FIRE & SAFETY AUDIT REPORT OF ALL THE BUILDINGS AT NABA DIGANTA

Volume II

Naba Diganta Industrial Township Authority

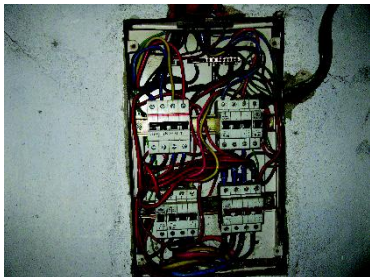
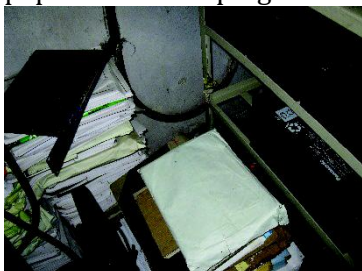
105.	Is there any deviation from the existing recommendation, if any, already been provided by Fire & Emergency Services	No
106	Particulars of premises or part of premises used for storage, use, process of substances require Fire License	NO
107	Is Trade License available??	No
108	Name of the Insurance Company	NO
109	Remarks (if any) 1. In the Ground floor UPS room Electrical box found without cover 2. Both the UPS room were found full of papers. Hose keeping is extremely poor 3. Hammer is missing in the MCP Box. It appears that it is not functioning 4. There is no proper signage available in the exit route 5. Ground floor Smoke detectors are not working. On investigation 4 nos Zones were found off at the intelligent panel 6. No mock fire drill and Evacuation drill has been conducted 7. No trained firefighting persons are available

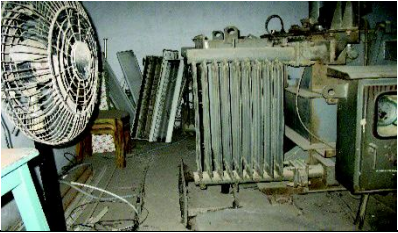
108.	Is there any deviation from the existing recommendation, if any, already been provided by Fire & Emergency Services	Yes	■ Deviation From Provisional NOC
109.	Particulars of premises or part of premises used for storage, use, process of substances require Fire License	No	
	Is Trade License available??	Yes available	
110	Name of the Insurance Company	Bajaj Allianz	
111	Remarks (if any) 1. No evacuation plan made and displayed 2. No ELCBs or RCCBs are connected with the electrical circuits 3. No public address system is found 4. Earth pit is not tested 5. NOC from WBF&ES is not available 6. Transformer room is full of unwanted combustible materials 7. Sand buckets are found dirty & half filled 8. LT Room is being used as residential room

Sl.No	OBSERVATIONS	RECOMMENDATIONS
1	No evacuation plan made and displayed	Evacuation plan is to be displayed in each floor
2	No ELCBs or RCCBs are found	To be connected in the distribution board of suitable ratings
3	Earth pit is not tested	To be tested periodically and test reports to be kept
4	Valid NOC from WBF&ES is not available	NOC is to be obtained from WBF&ES
5	No public address system is found	PAS to be installed
6	Transformer room is full of unwanted combustible materials 	Transformer room should be kept absolutely cleaned
7	Sand buckets are found dirty & half filled 	Free flowing sand to be kept full in all the sand buckets
8	LT Room is being used as residential room  	LT room should be kept absolutely clear of any unwanted materials

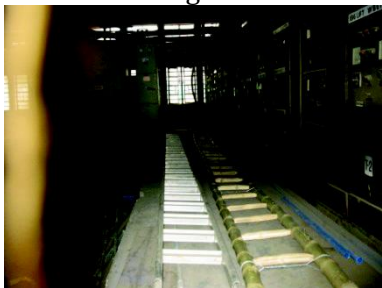
115	Is there any deviation from the existing recommendation, if any, already been provided by Fire & Emergency Services	No NOCfound from WBF &ES
116	Particulars of premises or part of premises used for storage, use, process of substances require Fire License	NO
	Is Trade License available??	NO
117	Name of the Insurance Company	NO
118	Remarks (if any) The management is planning to upgrade fire protection & Fire prevention system. Enquiry has been floated accordingly as per provisional NOC no WBFES DG/FP/ 1888/12/Kol/ BB/571/ 12(571/12), Dated- 19.06.2012

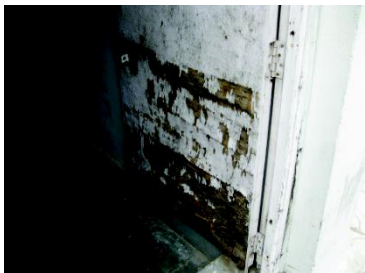
113	Is there any deviation from the existing recommendation, if any, already been provided by Fire & Emergency Services	Yes from WBF&ES recommendation
114	Particulars of premises or part of premises used for storage, use, process of substances require Fire License	No
	Is Trade License available??	No
115	Name of the Insurance Company	Tata AIG
116	Remarks (if any) 24. No Evacuation drill has been conducted 25. No mock drill has been conducted 26. No Assembly point has been enmarked 27. There is no evacuation plan is available 28. There is no fire trained person available 29. There is no ELCB or RCCB installed 30. FHC cabinet at the yard found empty 31. Emergency stair door at the roof top is found broken 32. On 6th floor the space of the refuse area is occupied by AC machines 33. Railing is to be provided on the emergency stair exit stair at the ground floor
